Proposal for Amendments to UN Regulation No. 34

(prevention of fire risks)

The text reproduced below was prepared by the expert from OICA for removing the categories M1 and N1 from the scope of the regulation. The modifications to the current text of the regulation are marked in bold for new and strikethrough for deleted characters.

“Model B
(See paragraph 3.1.5. of this Regulation)

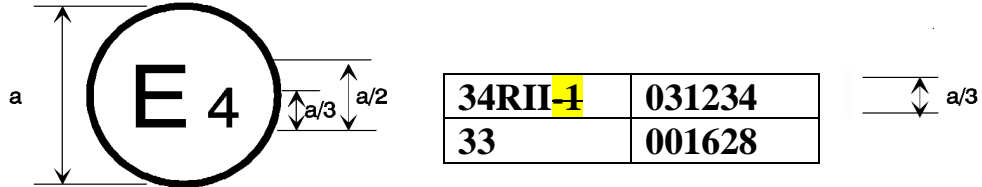
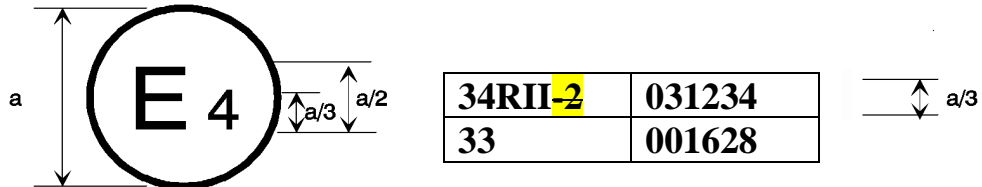
Annex 2, amend to read (changes highlighted in yellow – footnote unchanged):

The above approval mark affixed to a vehicle shows that the type concerned was approved in the Netherlands (E 4) pursuant to Regulations Nos. 34 Parts I or IV and II-1 and 33.* The approval numbers indicated that, at the date when the respective approvals were given, Regulation No. 34 included the 03 series of amendments and Regulation No. 33 was still in its original form.

The above approval mark affixed to a vehicle shows that the type concerned was approved in the Netherlands (E 4) pursuant to Regulations Nos. 34 Parts I or IV and II-2 and 33.* The approval numbers indicated that, at the date when the respective approvals were given,..."
